**Re: PBA Fern Isle Park – Bid Addendum
Revisions/Updates & Clarifications to Bid Set**

The purpose of this letter is to clarify all revisions and updates of the originally provided Bid Set.

SEAMLESS FLOOR TO WALL TRANSITION

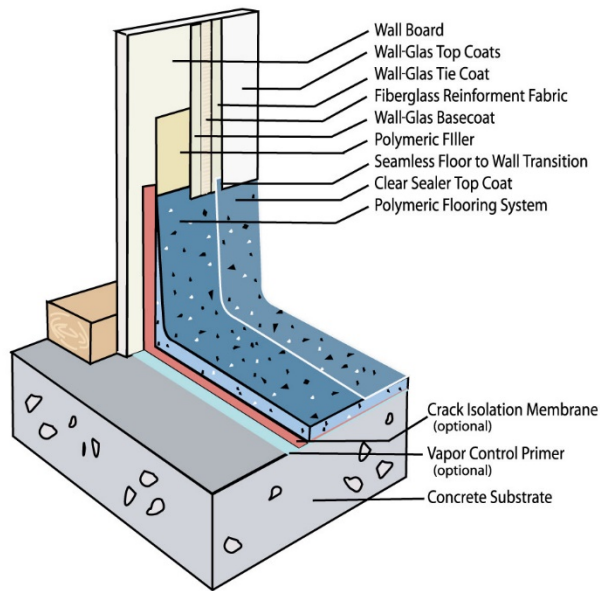
- *Dex-O-Tex Epoxy Floor Finish → The wall system is Dex-o-Tex Wallcote “E”. The floor is Dex-O-Tex Décor-Flor with a “sanitary cove”. Color to be selected by Architect.*
